of Decisions Re Land Use Application for 103  
Pike Street, Project 3028428-LU

Hearing Examiner File:  
**MUP-20-003**

## MEMORANDUM

<b>Date:</b>	November 20, 2019	<b>TG:</b>	1.16575.00
<b>To:</b>	John Shaw – SDCI	<b>MUP:</b>	3028428-LU
<b>From:</b>	Stefanie Herzstein, PE, PTOE – Transpo Group Jessica Lambert – Transpo Group		
<b>Cc:</b>	Douglas Buck – Marketview Place Associates, LLC		
<b>Subject:</b>	103 Pike Response to Correction Notice #1 (Correction 3)

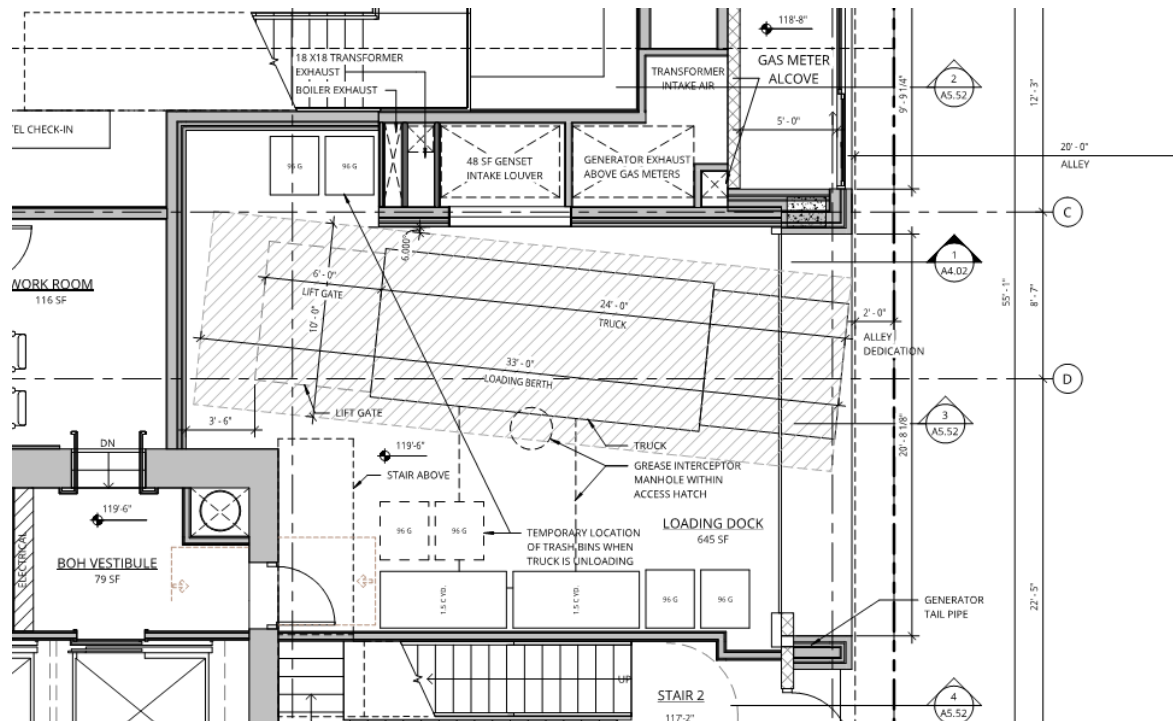
7. Appendix I, Page 2: Please provide additional details and dimensions in the loading dock analysis that outline where the waste containers will be staged at the time of collection, to ensure that waste collection can occur when the largest expected vehicle (identified as a 24' straight truck) is in the loading berth. Waste collection must be able to occur in the alley, with direct access to the containers, with any truck in the loading berth. The small size of the containers will necessitate collection three times a day and the functionality of the loading dock area is crucial for providing that required waste service.

**Response:** Appendix I has been updated to include the diagram below illustrating the staging for the waste collection.
